BULLETIN #2

DATE June 21, 2018

PROJECT NAME Saint Kenneth Catholic Church
Worship Space Addition & Renovation

PROJECT NUMBER 2014166

Scale: 1/8" = 1'-0"
Sheet
A201

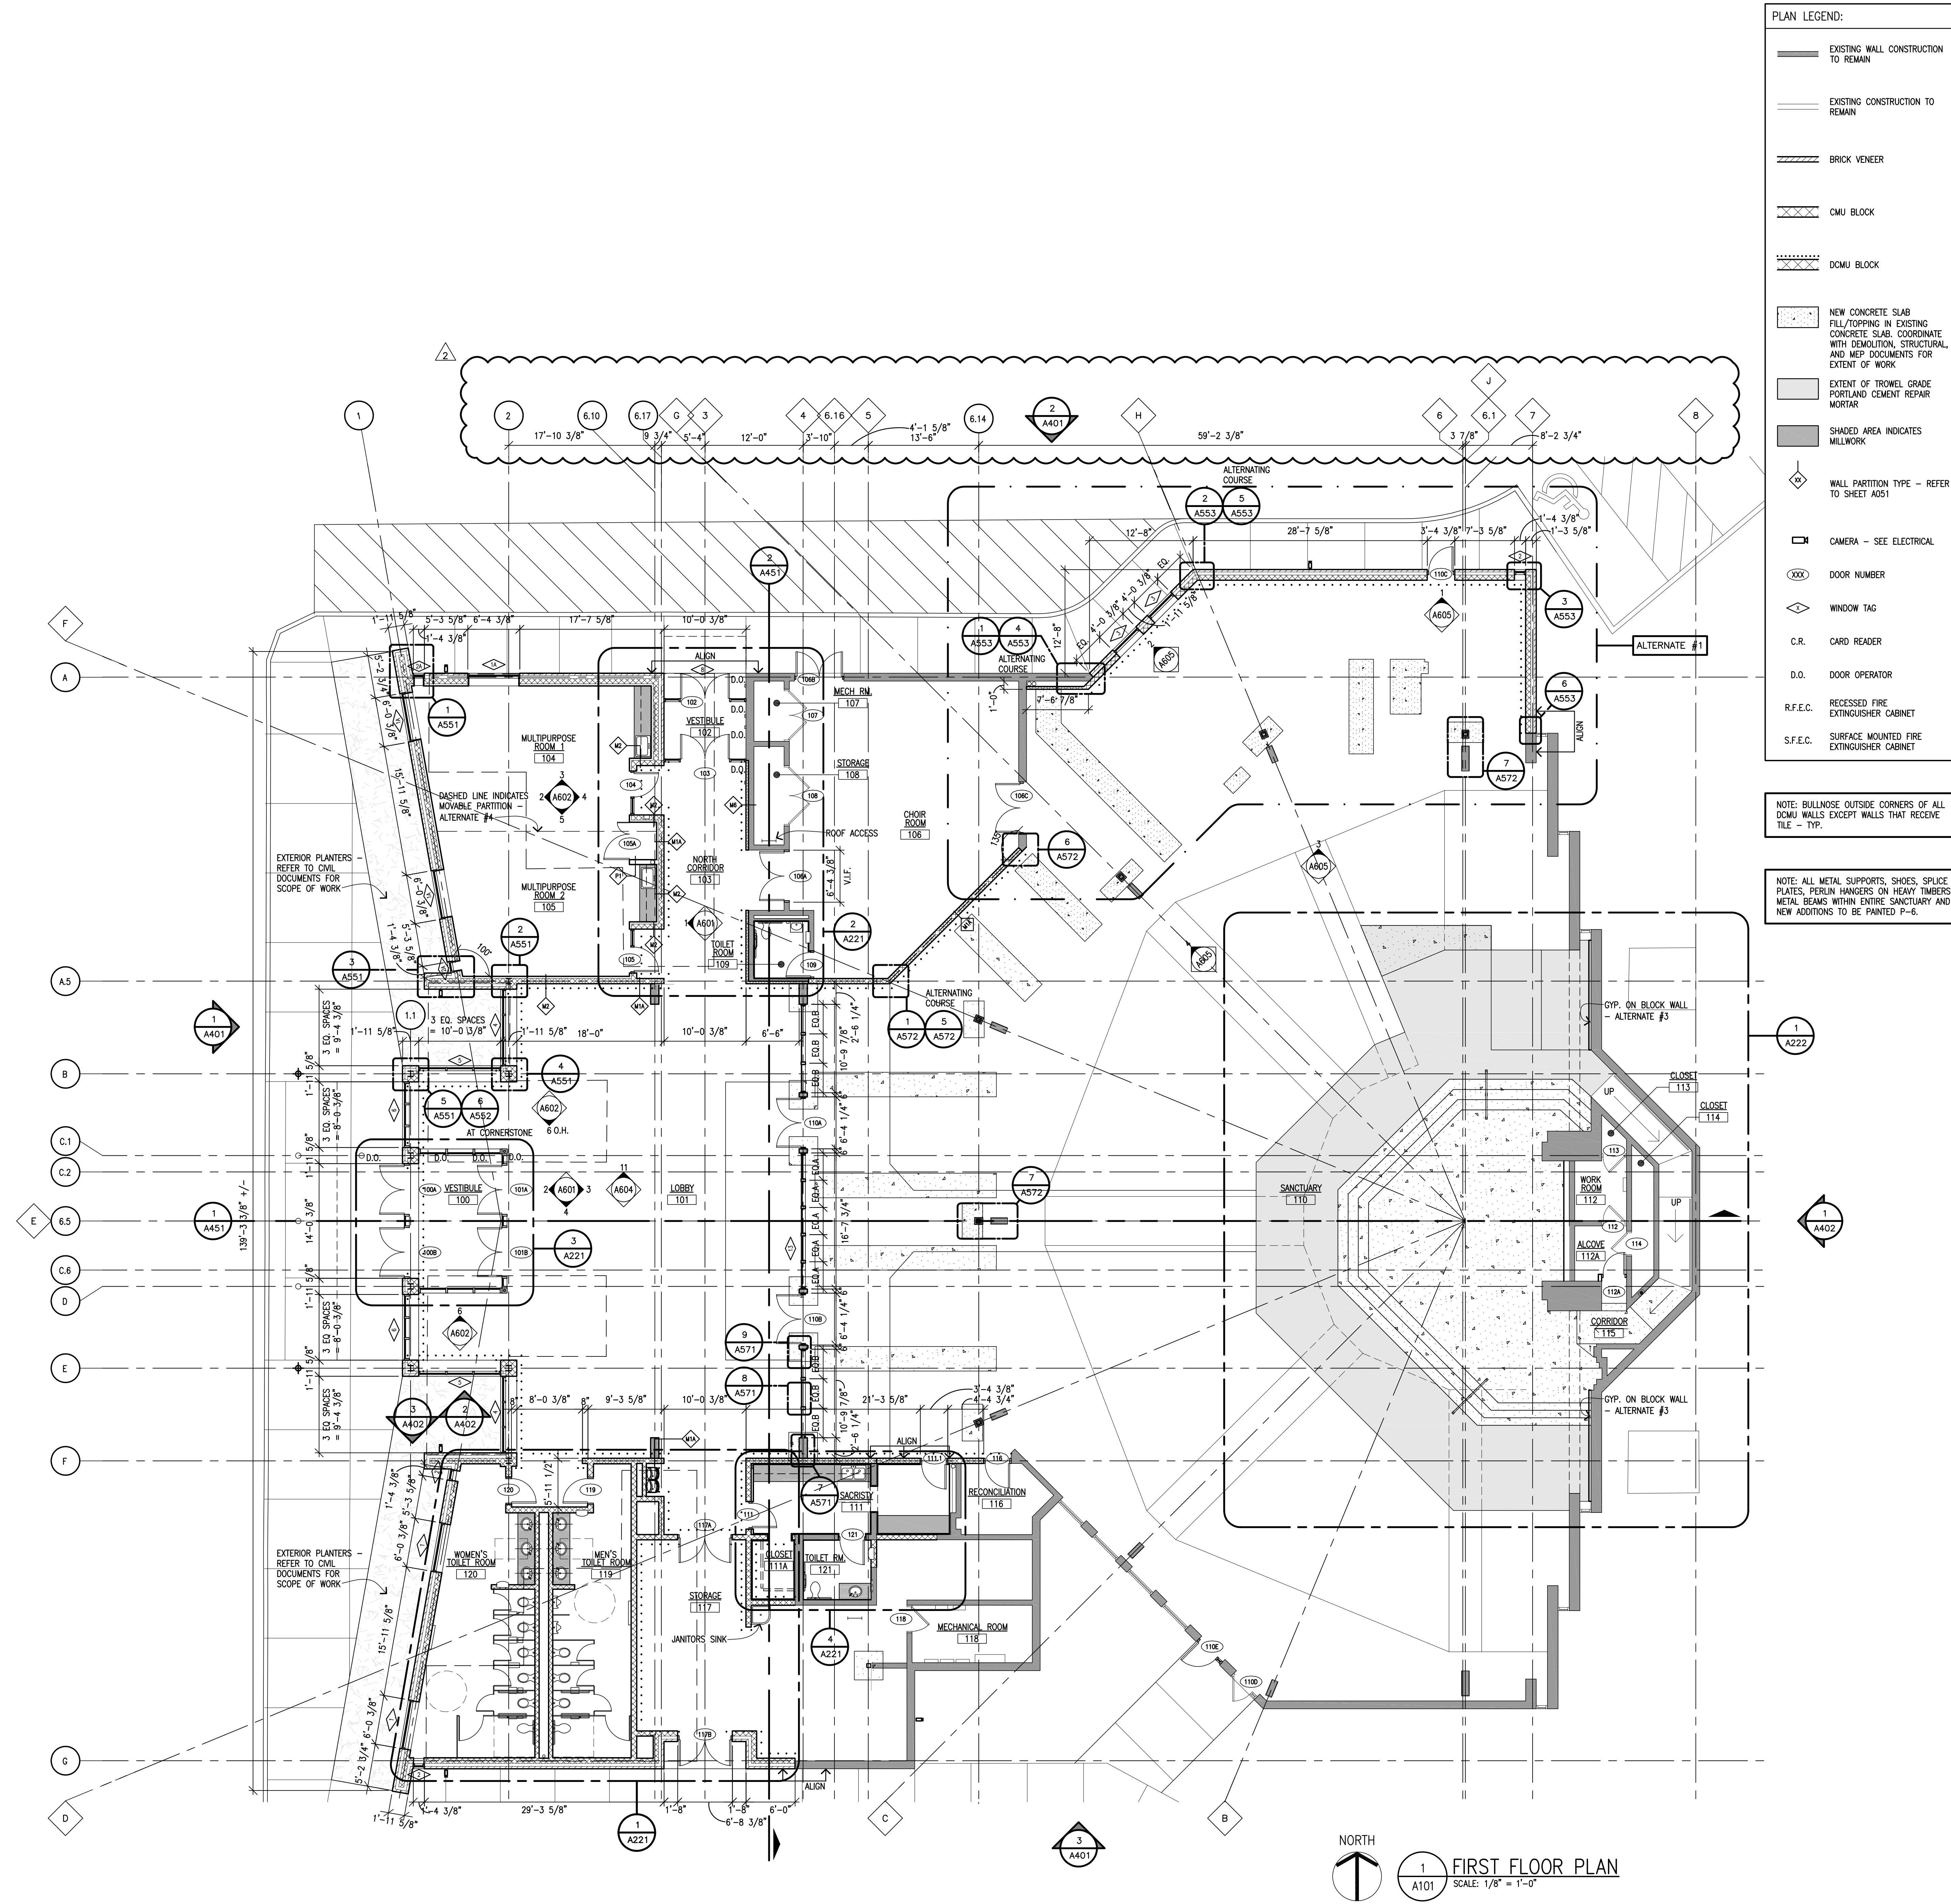
Item No. 2 – Structural Grid Clarification **Refer to Drawing A201**

- A. Clarification of column line spacing

Scale: 3/8" = 1'-0"
Sheet
A322

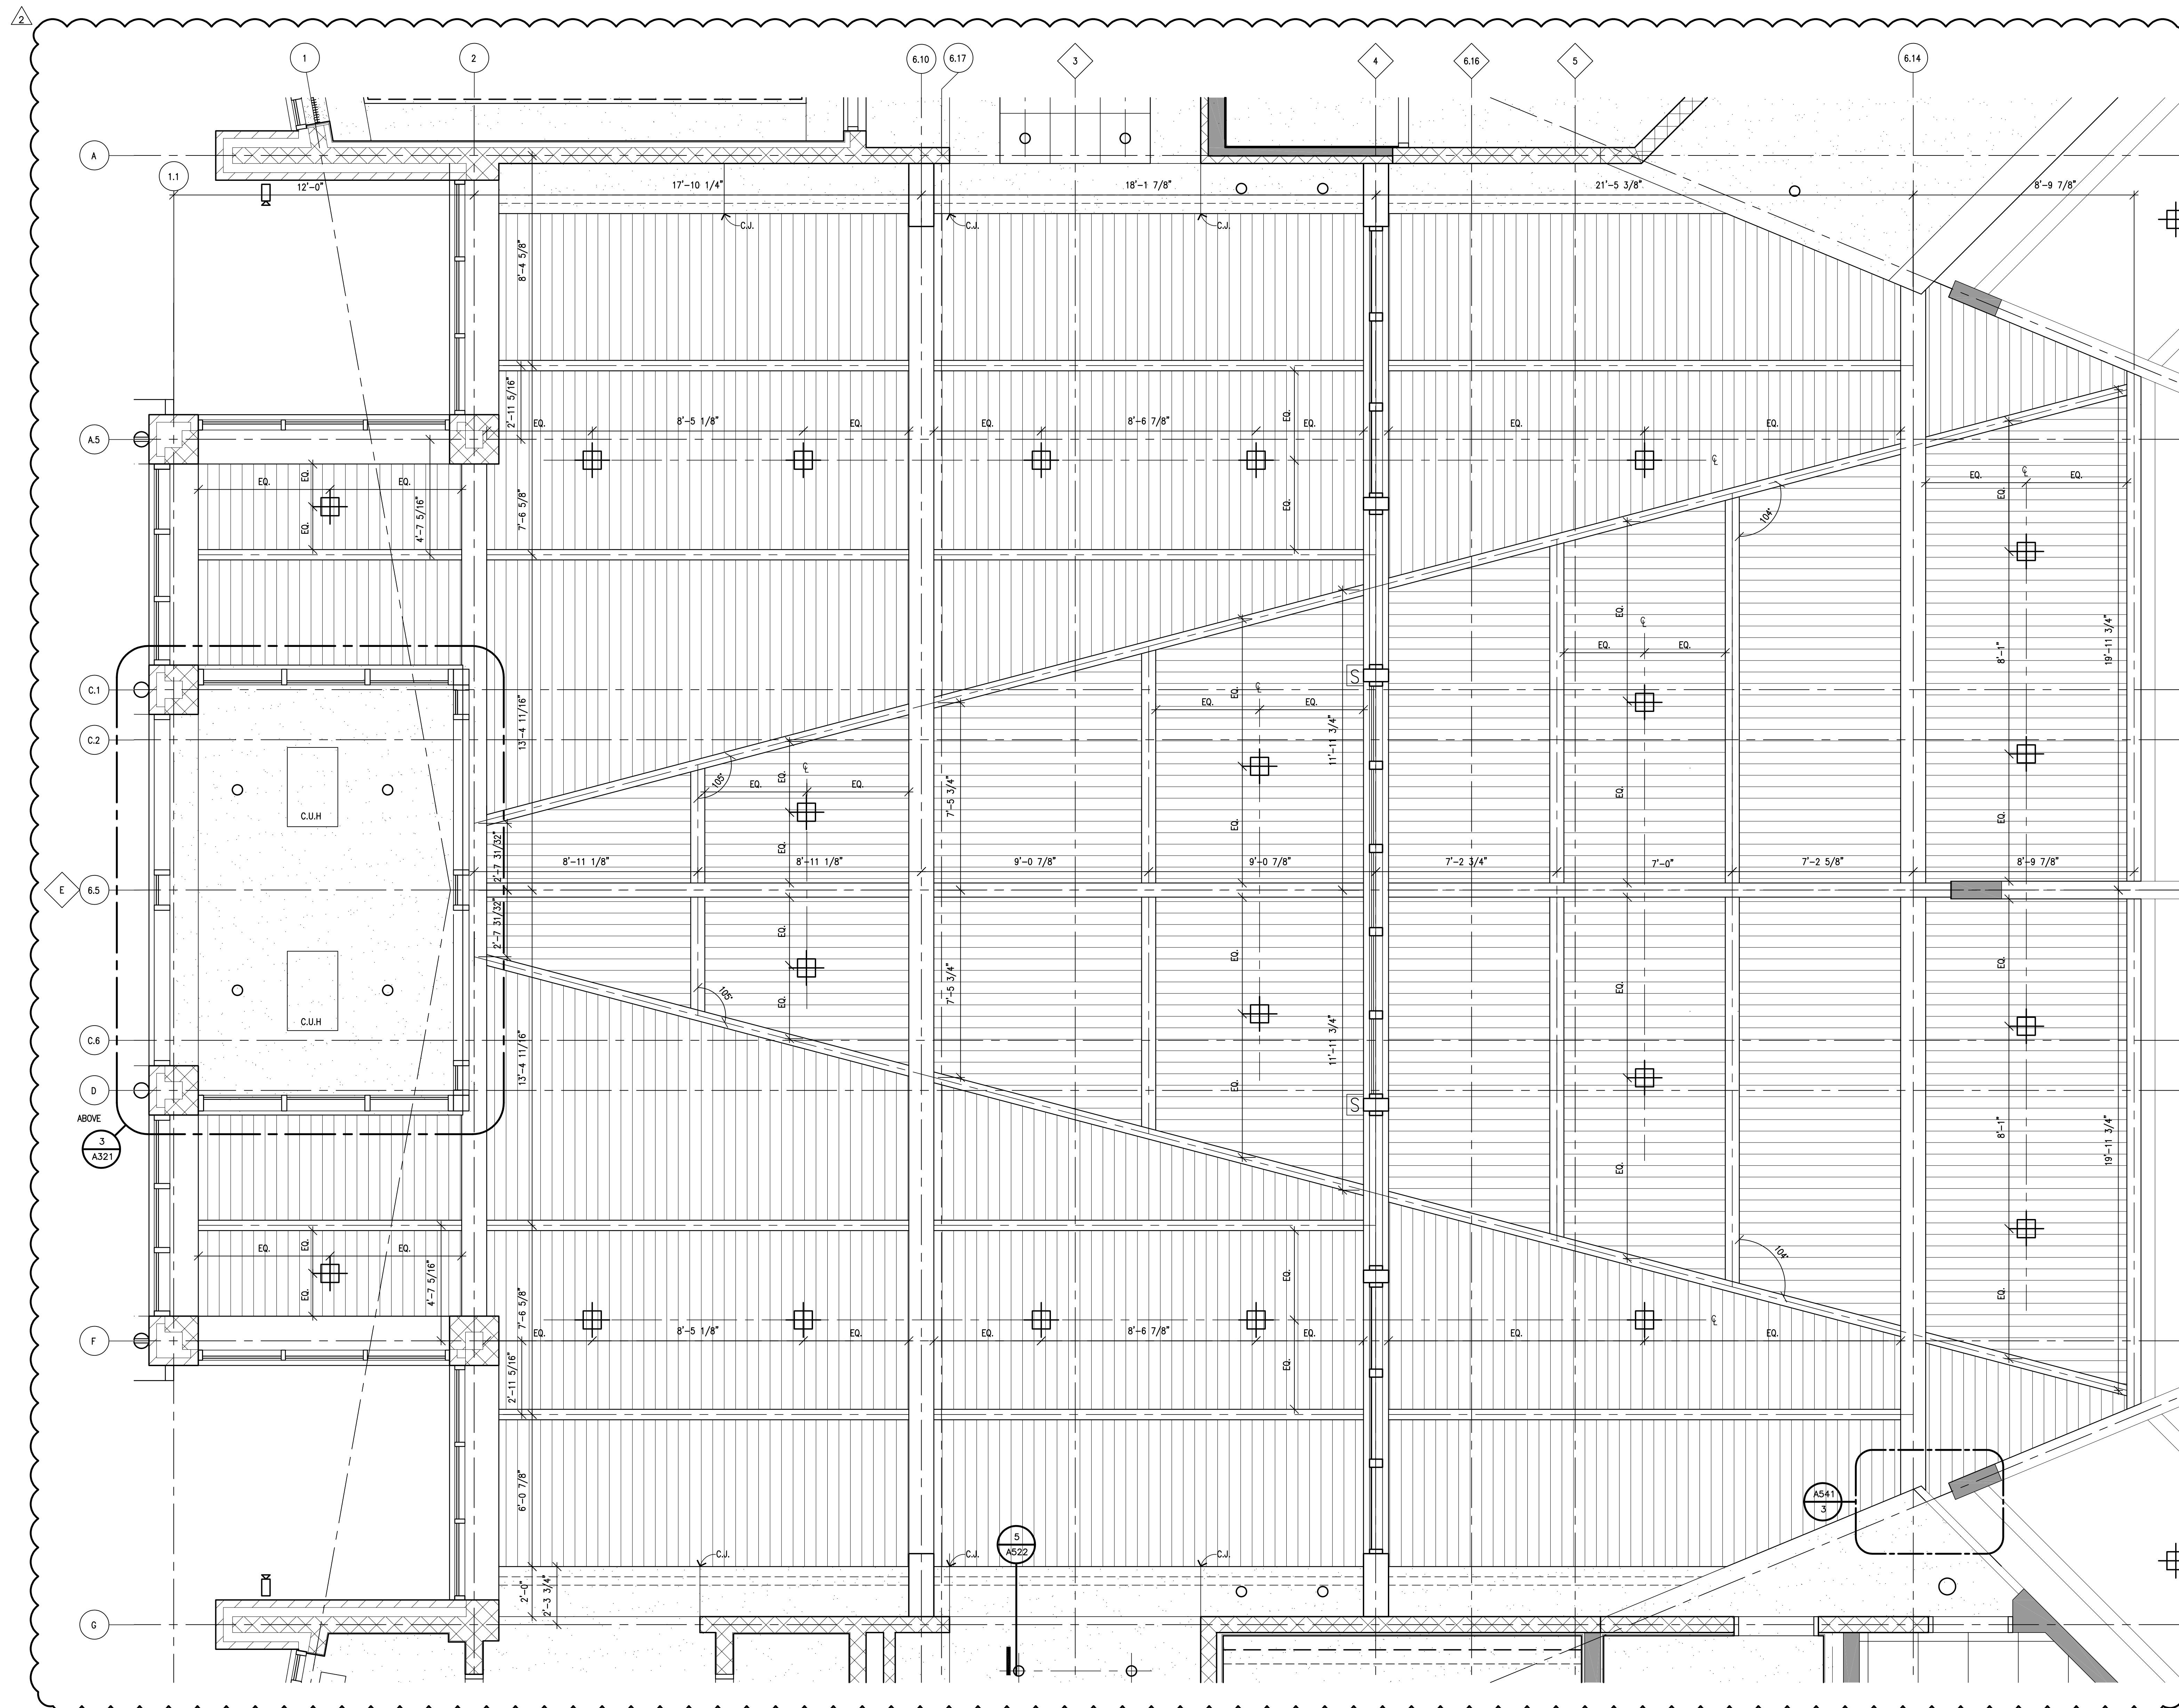
Item No. 4 – Wood Timber Dimension Clarifications
Refer to Drawing A202, A322,

- A. Clarification on wood timber framing locations on reflected ceiling and rood plan.

Sheet
A521

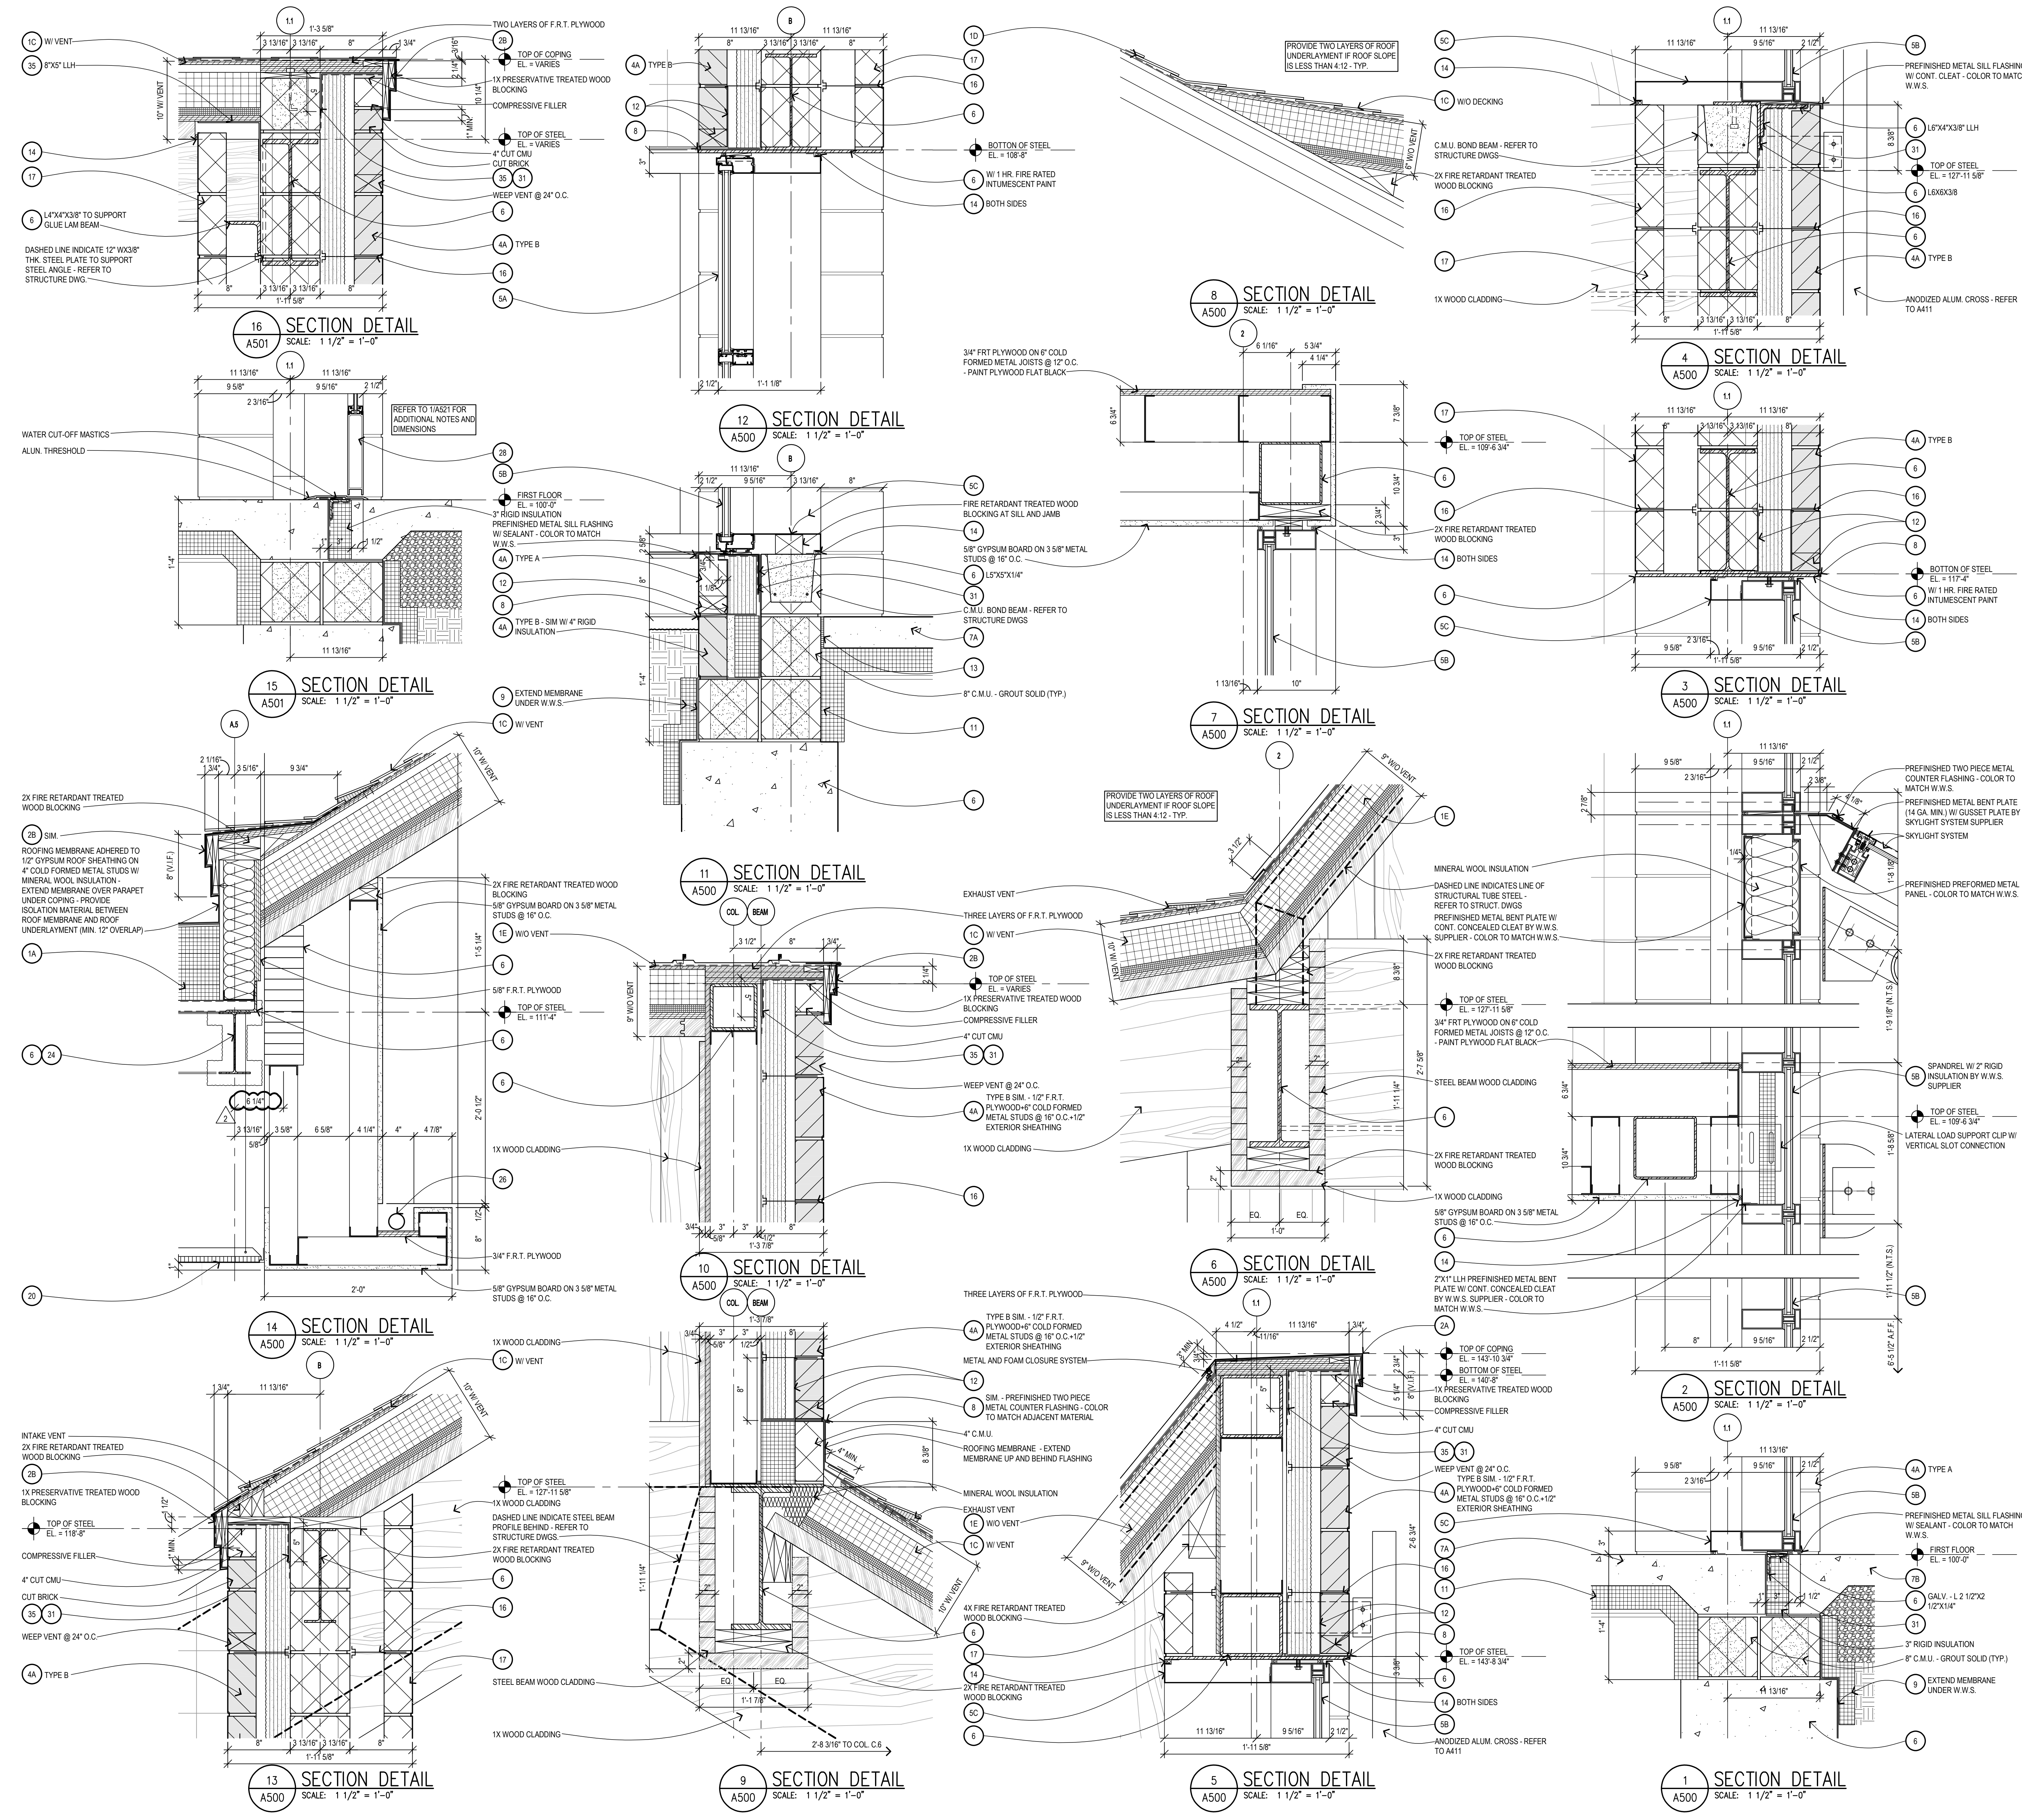
- A. Updated opening in screen walls to coordinate with plan locations on A402.
- B. Additional dimensions provided on detail 14/A521
- C. Dimension clarification on wood window system on A411, and A601
